# REGIONAL REVIEW FINDING

ARC REVIEW CODE: R510171

**Submitting Local Government:** City of Atlanta  
**Name of Proposal:** Lindmont Redevelopment

Preliminary Report:	October 17, 2005	<b>DEVELOPMENT OF REGIONAL IMPACT REVIEW REPORT</b>	Project:	Lindmont Redevelopment #921
Final Report Due:	November 16, 2005		Comments Due By:	November 1, 2005

1 MASTER PLAN  
A100 T = 50'-0"

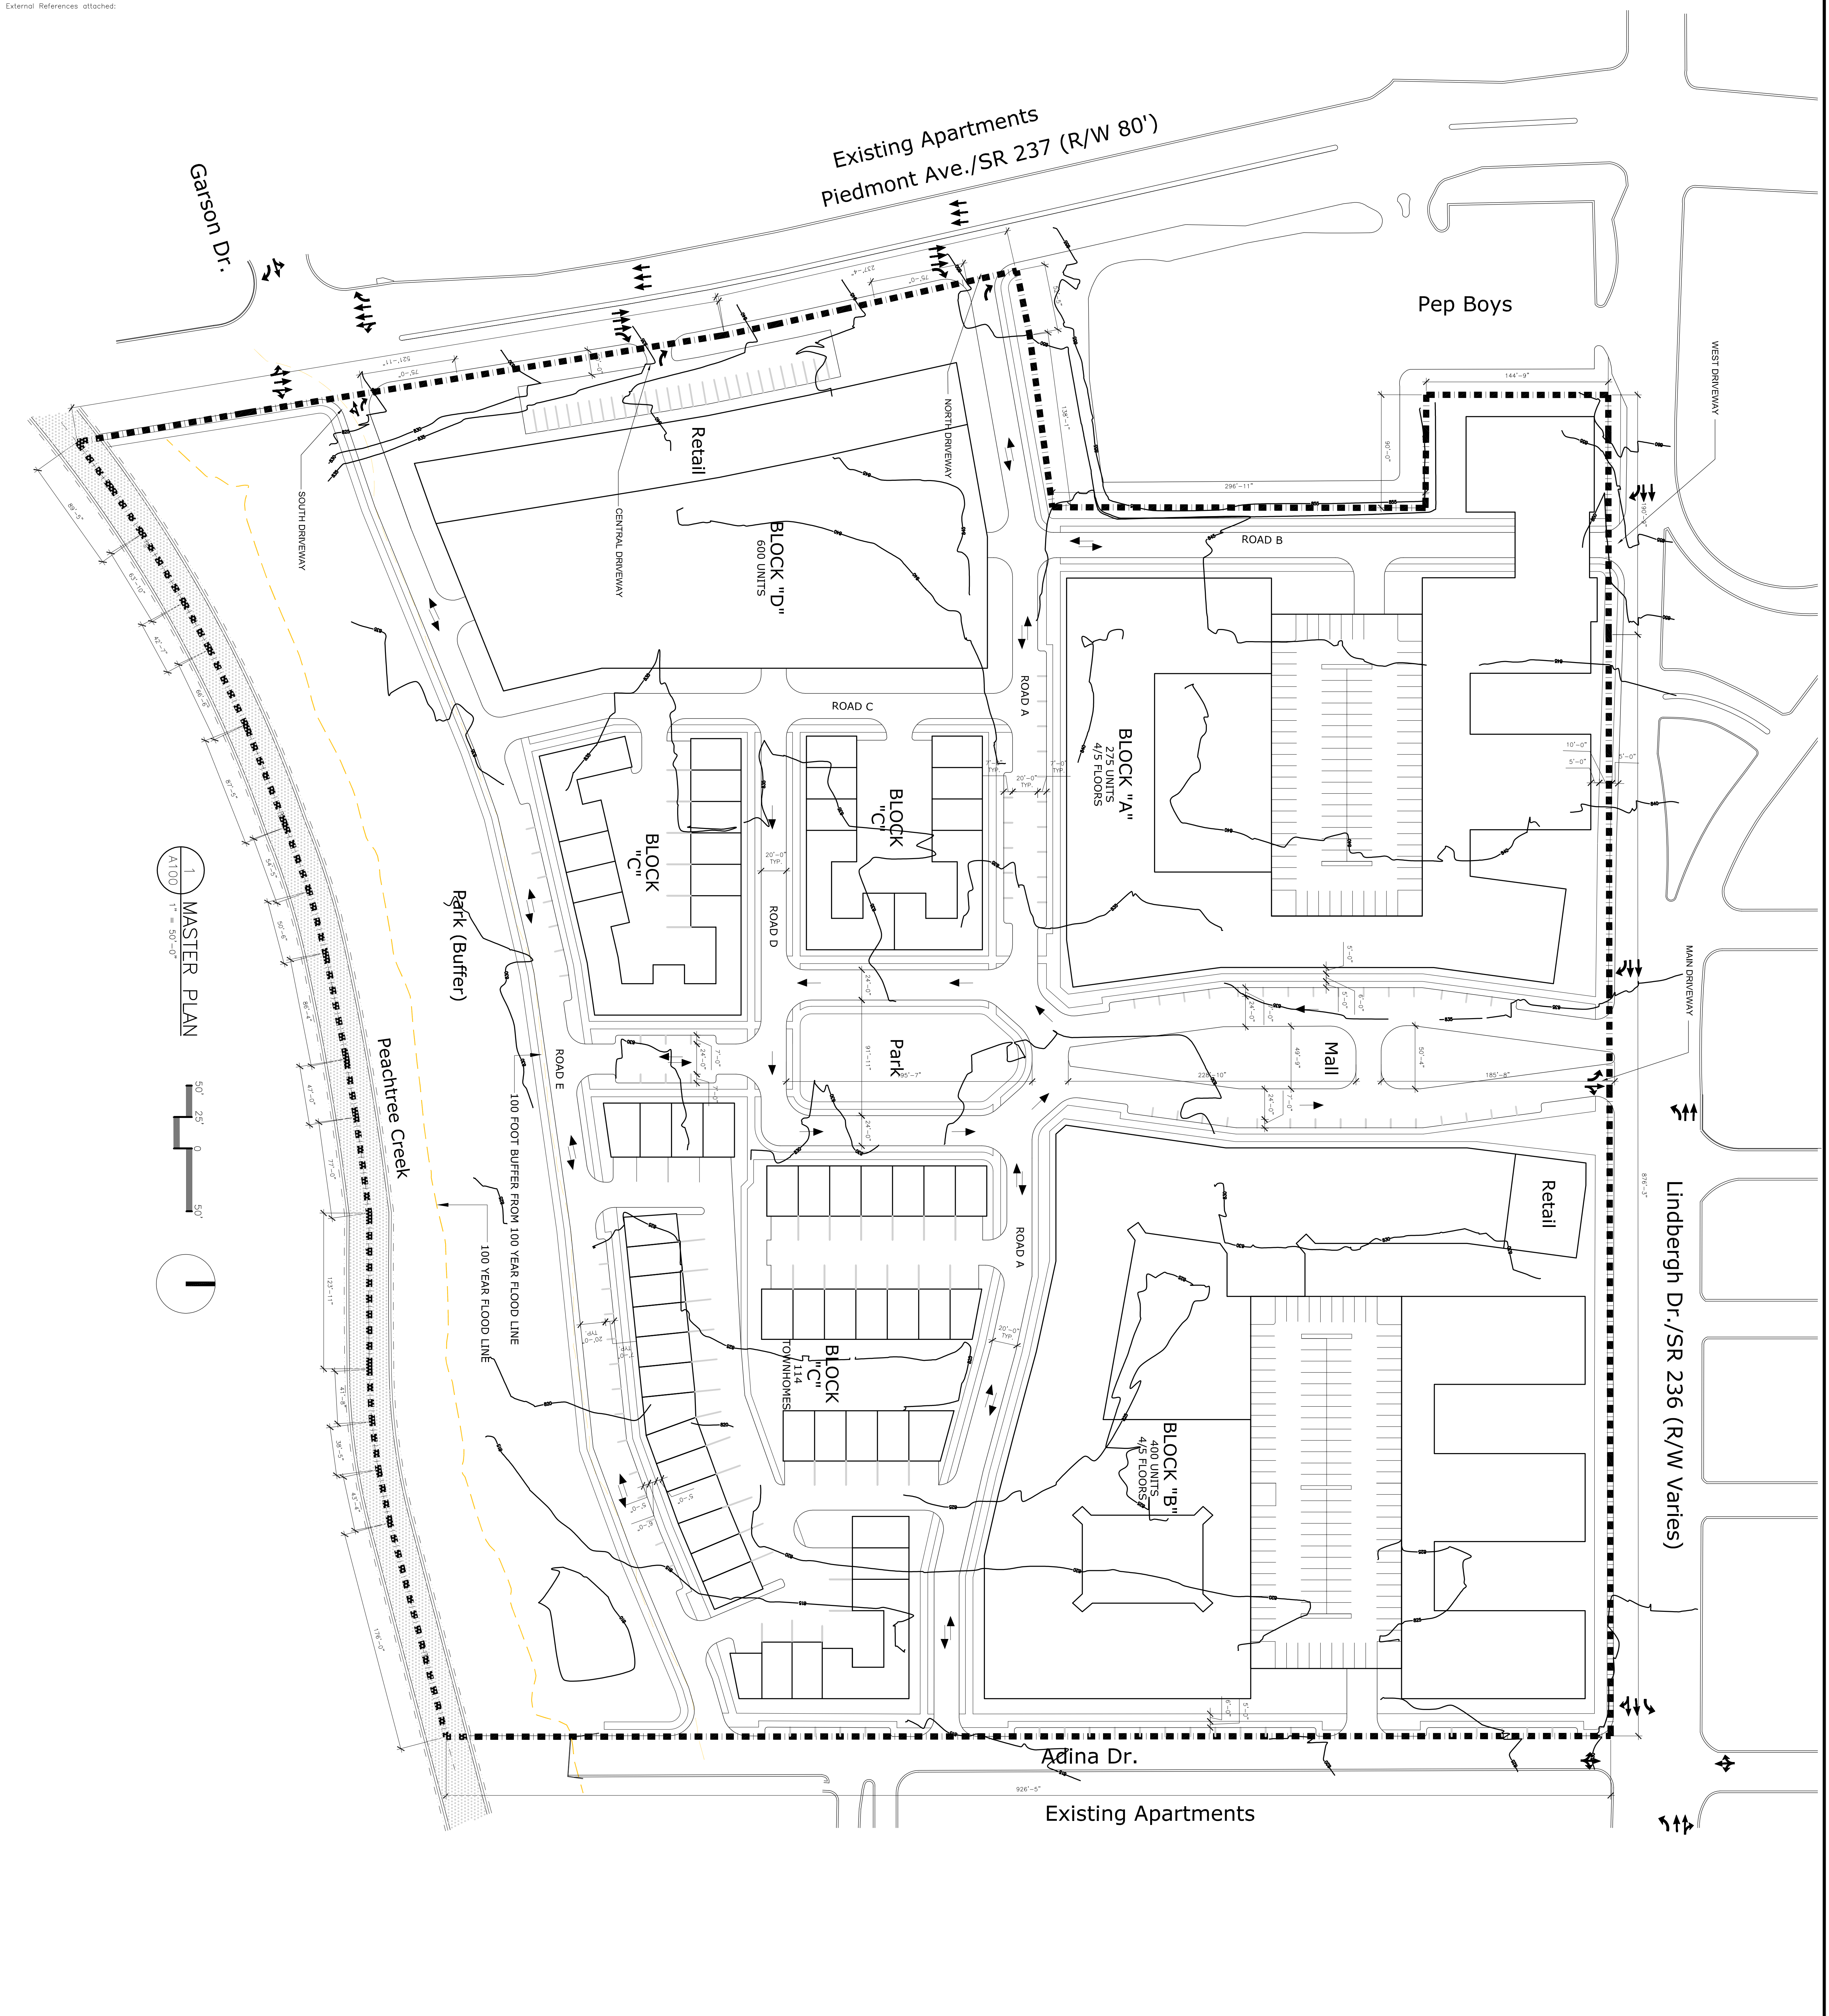
Information submitted during the review suggests that the residential component in Block D of the site plan will be one of the last parts of the development to be constructed. It is important to ensure that part of the development is built as shown on the site plan or similar to it. As the site plan is amended through the review and approval process, the development of Block D into a mix of residential and commercial uses that is compatible with the design of the remainder of the site is important. Auto oriented development should be deterred from this portion of the site.

It is recommended that parking along Piedmont Avenue to the retail portion of Block D be limited to no more than one row of parking, as shown on the site plan. It is encouraged that minimum setbacks are required for buildings with street frontage to ensure the creation of pedestrian oriented environment.

Peachtree Creek forms the southern boundary of the project property and drains to the Corridor portion of the Chattahoochee River. The Metropolitan River Protection Act requires that local governments with land draining to the Corridor portion of the River adopt tributary buffer zone ordinances to protect tributaries flowing to the Chattahoochee. In addition, the Metropolitan North Georgia Water Planning District has required local governments in the District to adopt stream buffer ordinances at least as effective as the District's model ordinance. The City of Atlanta has a stream buffer ordinance that meets both the Metro River Act and District requirements for streams in the City. The City Ordinance requires a 75-foot buffer along perennial and intermittent streams. The site plan shows a 100-foot buffer along Peachtree Creek.
